# Access Compliance Report

## Public Rights-of-Way

### (Curb Ramps)

Intersection ID: N/A	Main Street: TRYON_ST	Cross Street: WHITEHALL_ESTATE_DR	Location: SW
ADA ID: 802E20502B79	Ramp Type: PerpDiag	Initial Pass/Fail: Fail	Overall Compliance: No
Codes/Mitigation Info/Possible Solution		Field Measurements/Component Compliance

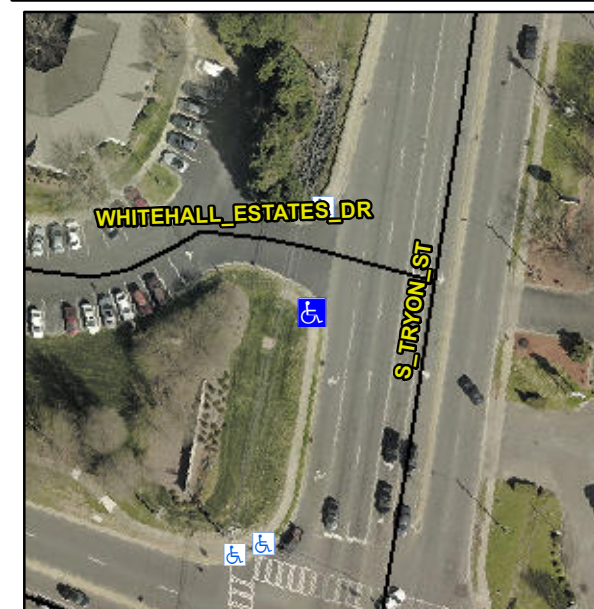
Compliance	Description	Data	Compliance	Description	Data
N/A	Ramp Length (in)	81.0	No	Ramp Slope (%)	8.4
No	Ramp Width (in)	39.0	Yes	Ramp XSlope (%)	1.6
N/A	Flare Type LT	N/A	N/A	Flare Type RT	N/A
N/A	Flare Slope LT (%)	N/A	N/A	Flare Slope RT (%)	N/A
N/A	Flare Traversable LT?	N/A	N/A	Flare Traversable RT?	N/A
N/A	Landing Length (in)	N/A	N/A	DWS Provided?	N/A
N/A	Landing Width (in)	N/A	N/A	DWS Contrast?	N/A
N/A	Landing Slope (%)	N/A	N/A	DWS Length (in)	N/A
N/A	Landing X Slope (%)	N/A	N/A	DWS Full Width?	N/A
N/A	Landing Curb? (Y/N)	N/A	N/A	DWS Offset (in)	N/A
N/A	Shared Landing?	N/A			
N/A	Gutter Ponding?	N/A	N/A	Gutter Slope (%)	N/A
N/A	Gutter Lip Ht (in)	N/A	N/A	Gutter X Slope (%)	N/A
N/A	Painted X Walk1?	No	N/A	Painted X Walk2?	No
	X Walk 1 Direction	To E		X Walk 2 Direction	To N
N/A	X Walk 1 Width (in)	N/A	N/A	X Walk 2 Width (in)	N/A
	X Walk 1 Slope (%)	4.8		X Walk 2 Slope (%)	2.0
	X Walk 1 X Slope (%)	0.0		X Walk 2 X Slope (%)	4.1

**Remove & Replace Curb Ramp With Two New Directional Ramps or Equivalent.**
